# **OMA relaxation for high extinction ratio transmitters**

John Johnson, Broadcom Inc.

100G-EPON

This contribution is in support of comments by the author against draft D1.1.

# PR30 US: Cooled ONU TX

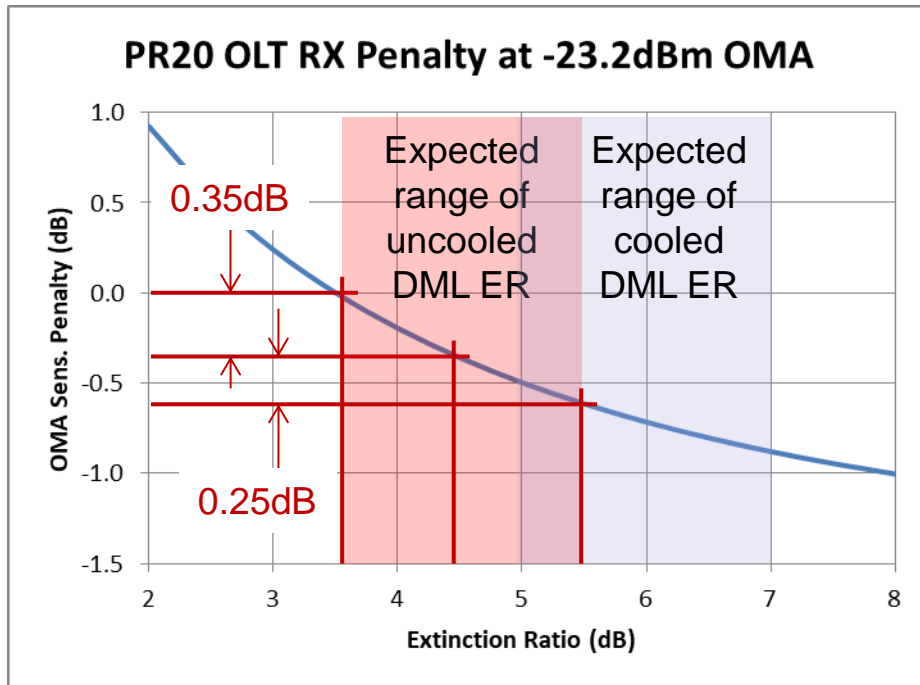
- RX OMA Sens. (min) = -24.8dBm at minimum ER = 5dB.
- ONU TX is expected to be a **cooled DML** for PR30 PMDs
- Cooled DML ER can range from 5dB (min) to ~7dB at the high end.
- ONU TX with ER ≥ 6dB need **0.2dB lower OMA** for same OLT RX sensitivity as an ONU TX with ER = 5dB.
- **Propose relaxation of 0.2dB in OMA minus TDP (min) for PR30 ONU TX with ER ≥ 6dB.**

Description	Value	Unit
Launch power in OMA minus TDP, each lane (min):		
for extinction ratio ≥ 6 dB	4	dBm
for extinction ratio < 6 dB	4.2

# PR20 US: Uncooled ONU TX

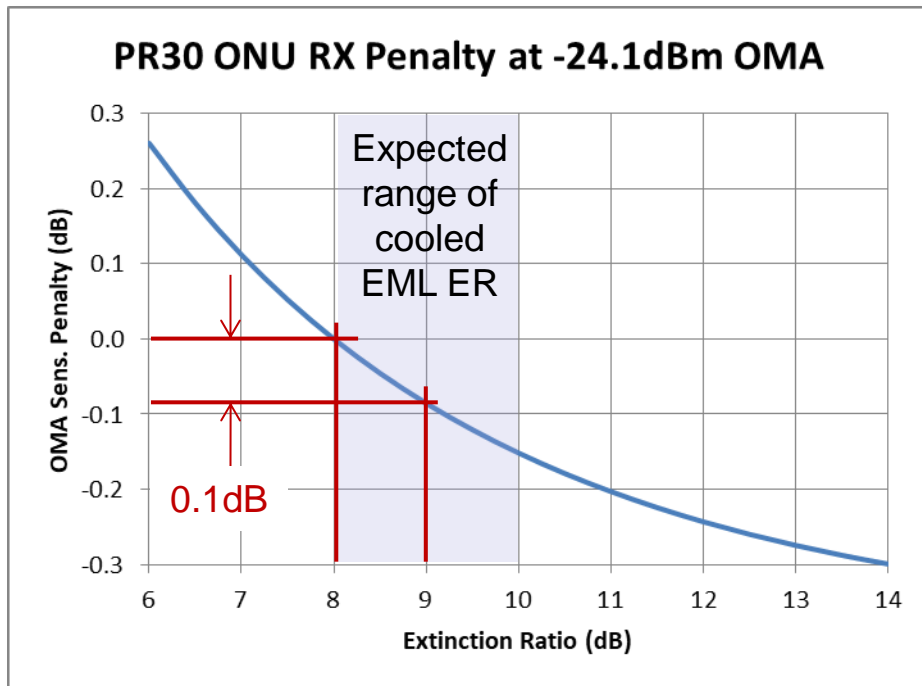
- RX OMA Sens. (min) = -23.2dBm at minimum ER = 3.5dB.
- ONU TX is expected to be an **uncooled DML** for PR20 25G PMDs, but 50/50G ONUs may use **cooled DMLs** to overcome mux losses.
- Uncooled DML ER can range from 3.5dB (min) to ~5.5dB at the high end. Cooled DML ER can be up to ~7dB.
- ONU TX with ER > 4.5dB need **0.35dB lower OMA** for same OLT RX sensitivity as an ONU TX with ER = 3.5dB. (Cooled) ONU TX with ER > 5.5dB need 0.6dB lower OMA.
- **Propose relaxation of 0.3dB in OMA minus TDP (min) for PR20 ONU TX with ER  $\geq 4.5$ dB, and 0.6dB relaxation for ER  $\geq 5.5$ dB.**

Description	Value	Unit
Launch power in OMA minus TDP, each lane (min):		
for extinction ratio $\geq 5.5$ dB	0.2	
for extinction ratio $\geq 4.5$ dB	0.5	dBm
for extinction ratio $< 4.5$ dB	0.8

# PR30 DS: Cooled EML TX

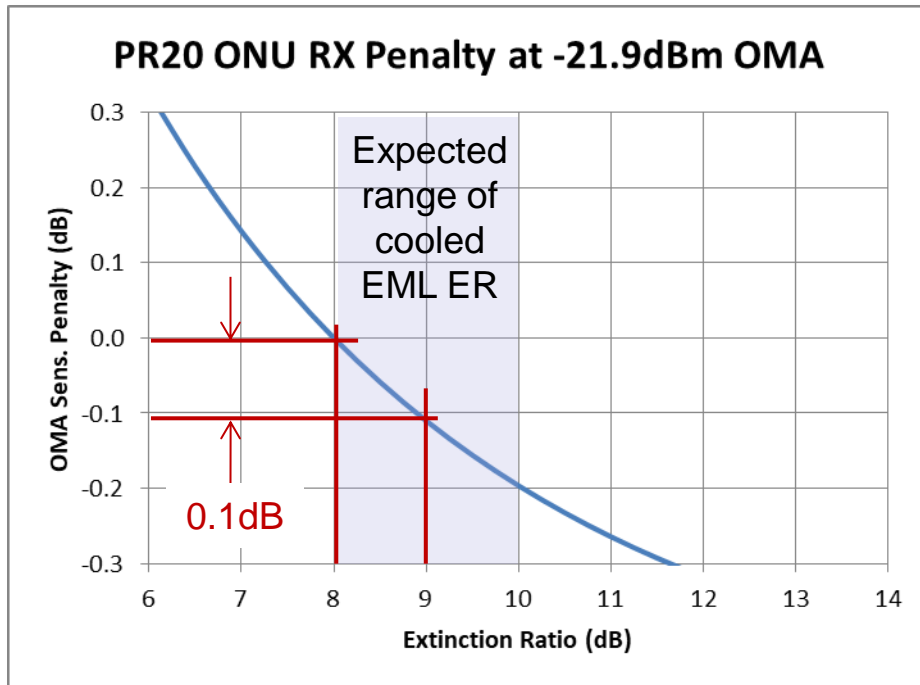
- RX OMA Sens. (min) = -24.1dBm at minimum ER = 8dB.
- ONU TX is expected to be a **cooled EML**.
- Cooled EML ER can range from 8dB (min) to ~10dB at the high end.
- ONU TX with ER > 9dB need **0.1dB lower OMA** for same OLT RX sensitivity as an ONU TX with ER = 8dB.
- **Propose relaxation of 0.1dB in OMA minus TDP (min) for PR30 OLT TX with ER ≥ 9dB.**

Description	Value	Unit
Launch power in OMA minus TDP, each lane (min):		
for extinction ratio ≥ 9 dB	4.8	dBm
for extinction ratio < 9 dB	4.9
